TECHNICAL BULLETIN

20 February 2017

MODEL AFFECTED: UH-1H-II
SUBJECT: ALTERNATE GAS PRODUCER (N1) INDICATOR
HELICOPTERS AFFECTED: Kits K1 and sub

Figure 1

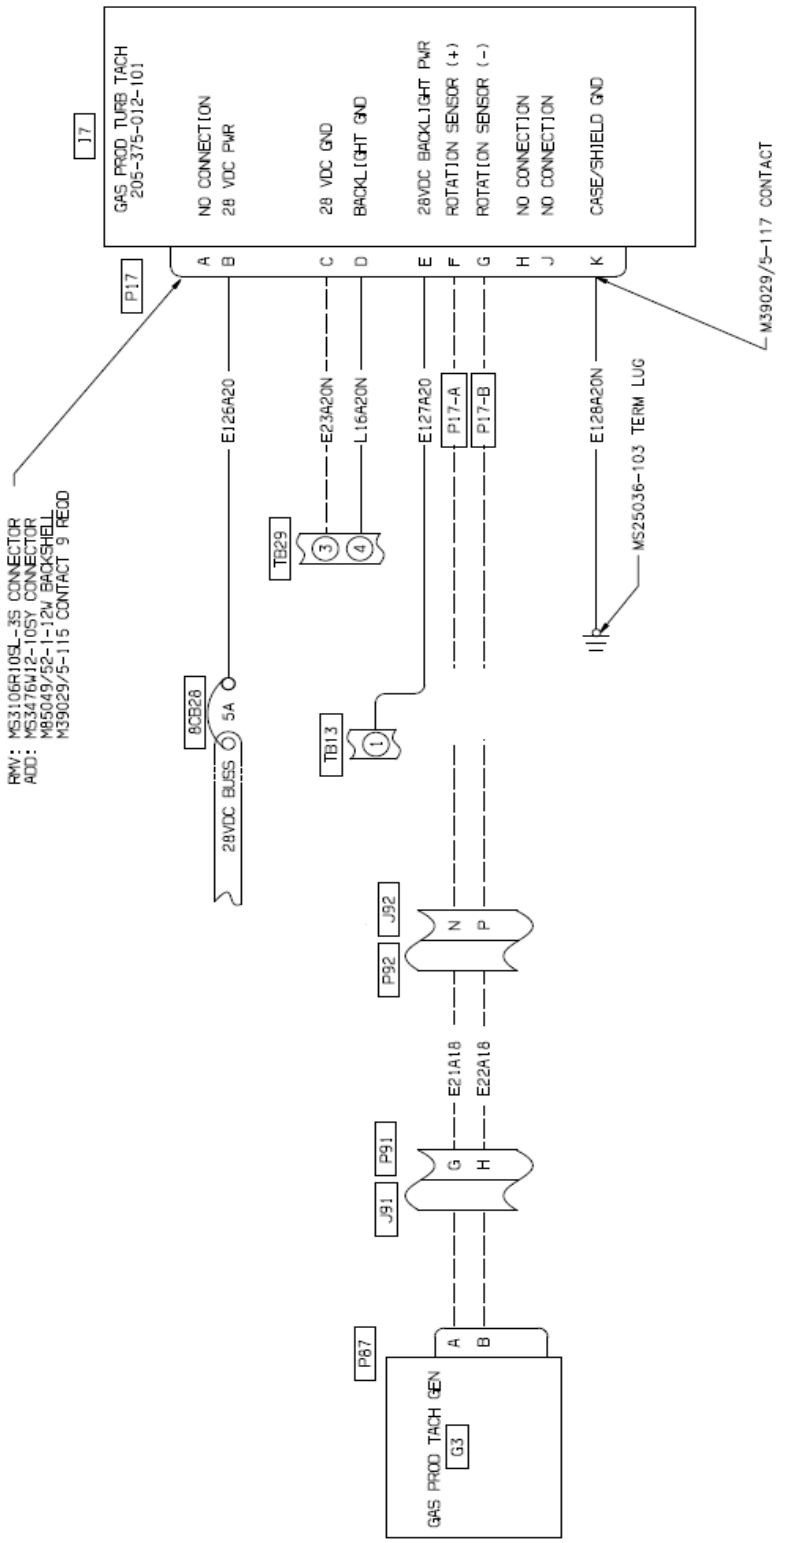
5. Remove P/N 8DJ81CSS-1/-2/-4 Gas Generator Indicator and discard.
6. Remove wires from P17 and discard connector.
7. Isolate wire L20S20. Disconnect wire LS20S20 from TB13 (1). Discard wire, reinstall TB13 terminal nut.
8. Referencing BHT-ELEC-SPM and Fig 1, install replacement connector P17
9. Referencing BHT-ELEC-SPM and Fig 1, fabricate and install wire E127A20.
10. Access N1 Gas Generator Circuit Breaker (5amp) Referencing BHT_ELEC-SPM and Fig 1 fabricate and install E125A20.
11. Confirm wires E23A20N and L18A20N are terminated at TB29 terminals 3 & 4.
12. Install replacement N1 Gas Gen Indicator P/N 205-375-012-101.
13. Reconnect battery,
14. Perform operational check of the N1 Gas Generator Indicator.
15. Make an entry in the helicopter logbook and Historical Service Records (HSR)
